POST TENDER ADDENDUM

JLG 16098 Bottineau Ridge II Apts

RE: post tender addendum 02

Issued: March 16, 2018

1 A421 SECTION AT STAIR 2
SCALE: 1/4" = 1'-0"

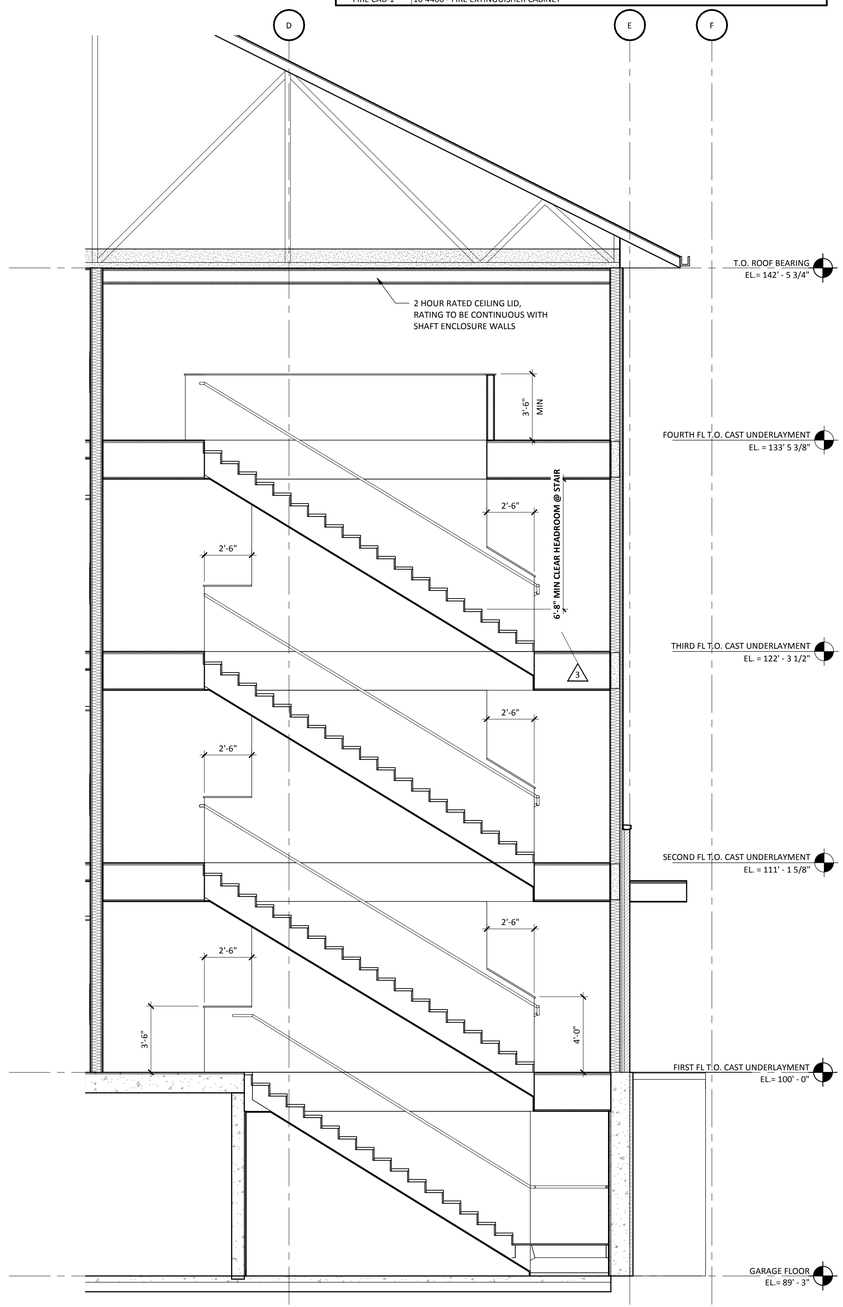
- Details 1 & 2/A420, revised enclosure walls from CMU to concrete.
31. A422 VERTICAL CIRCULATION – ELEVATOR – See attachment.
    - Details 1, 2 & 3/A422, revised enclosure walls from CMU to concrete.

6 A501 WALL SECTION @ AREA WELL
SCALE: 1/4" = 1'-0"

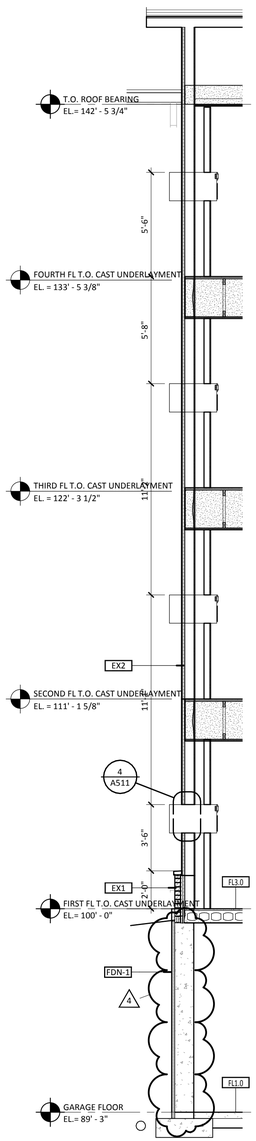
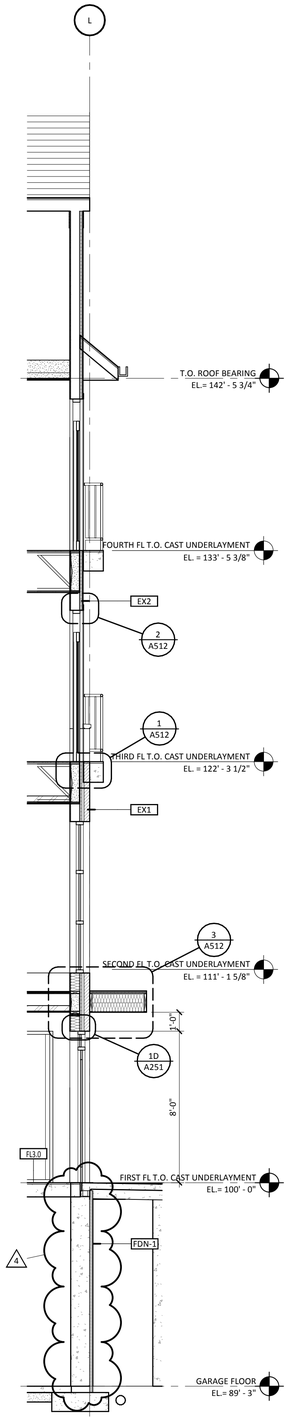
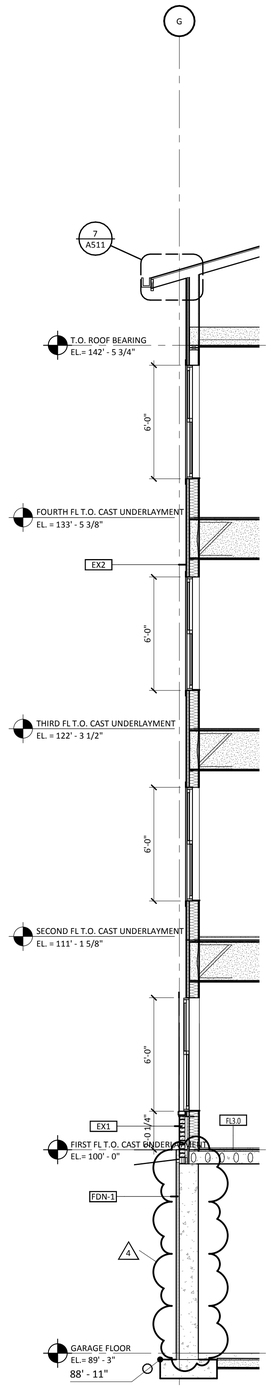
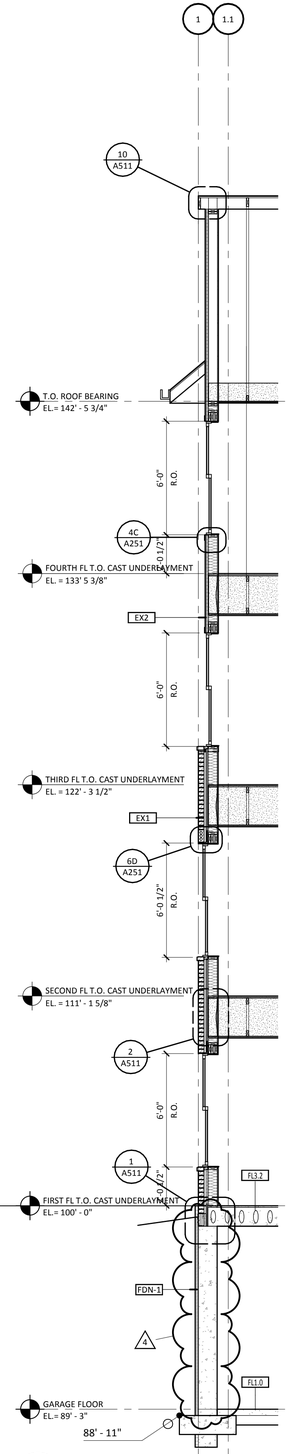
32. A501 EXTERIOR WALL SECTIONS – See attachment.
    - Details 1, 2, 3, 4, & 5/A501, revise foundation walls from CMU to concrete.
    - Detail 6/A501, revised foundation walls from CMU to concrete, and depth of area well.

12 A511 ELEVATOR SHAFT/PRECAST PLANK
SCALE: 1 1/2" = 1'-0"

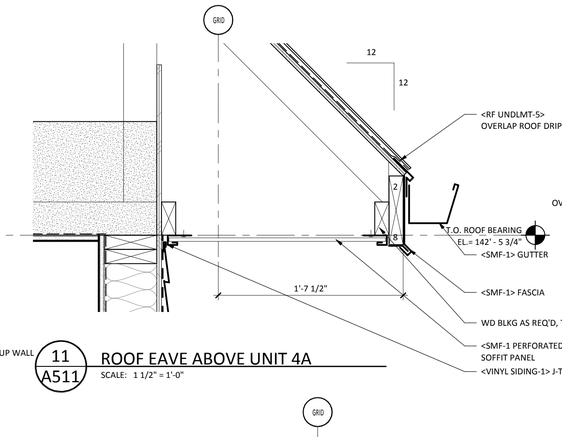
33. A511 SECTION DETAILS – See attachment.
    - Details 1, 8, 9 & 12/A511, revised foundation walls from CMU to concrete.
34. A512 SECTION DETAILS – See attachment.

4C A512 STAIR ENCLOSURE/PRECAST PLANK
SCALE: 1 1/2" = 1'-0"

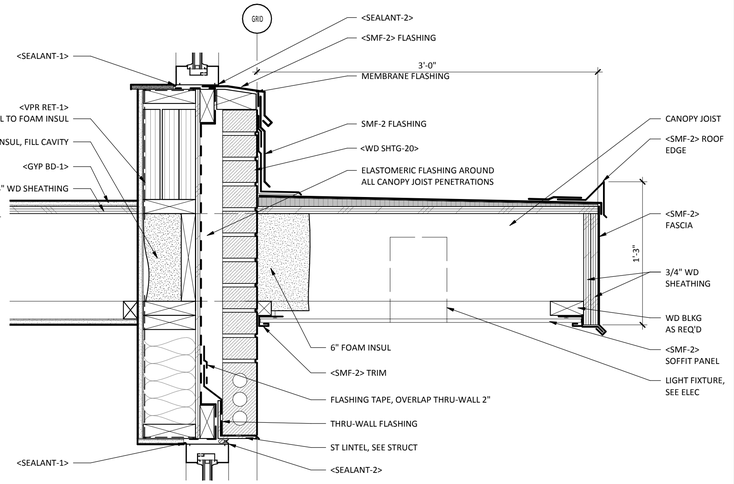
- Detail 4A & 4C/A512, revised foundation walls from CMU to concrete.
